Access Compliance Report

Public Rights-of-Way

(Curb Ramps)

Intersection ID: 10032191	Main Street: MORRISON_BV	Cross Street: N/A	Location: N
ADA ID: E9A27B0AA4CE	Ramp Type: PerpDiag	Initial Pass/Fail: Fail	Overall Compliance: No
Severity Score: 25			
Codes/Mitigation Info/Possible Solution		Field Measurements/Component Compliance

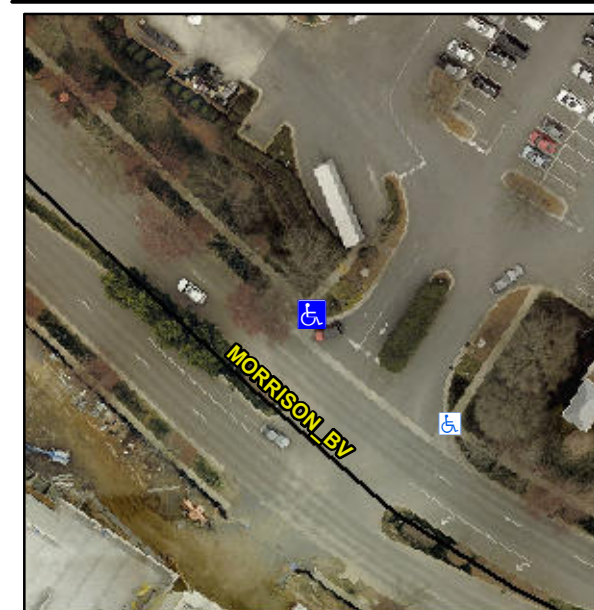
Not Found, R304.2.2

Compliance	Description	Data	Compliance	Description	Data
N/A	Ramp Length (in)	49.0	No	Ramp Slope (%)	18.0
Yes	Ramp Width (in)	48.0	Yes	Ramp XSlope (%)	1.0
N/A	Flare Type LT	N/A	N/A	Flare Type RT	N/A
N/A	Flare Slope LT (%)	N/A	N/A	Flare Slope RT (%)	N/A
N/A	Flare Traversable LT?	N/A	N/A	Flare Traversable RT?	N/A
N/A	Landing Length (in)	N/A	N/A	DWS Provided?	N/A
N/A	Landing Width (in)	N/A	N/A	DWS Contrast?	N/A
N/A	Landing Slope (%)	N/A	N/A	DWS Length (in)	N/A
N/A	Landing X Slope (%)	N/A	N/A	DWS Full Width?	N/A
N/A	Landing Curb? (Y/N)	N/A	N/A	DWS Offset (in)	N/A
N/A	Shared Landing?	N/A			
N/A	Gutter Ponding?	N/A	N/A	Gutter Slope (%)	N/A
N/A	Gutter Lip Ht (in)	N/A	N/A	Gutter X Slope (%)	N/A
N/A	Painted X Walk1?	No	N/A	Painted X Walk2?	No
	X Walk 1 Direction	To SW		X Walk 2 Direction	To SE
N/A	X Walk 1 Width (in)	N/A	N/A	X Walk 2 Width (in)	N/A
	X Walk 1 Slope (%)	2.6		X Walk 2 Slope (%)	5.7
	X Walk 1 X Slope (%)	3.9		X Walk 2 X Slope (%)	1.7

Remove & Replace Curb Ramp With Two New Directional Ramps or Equivalent.
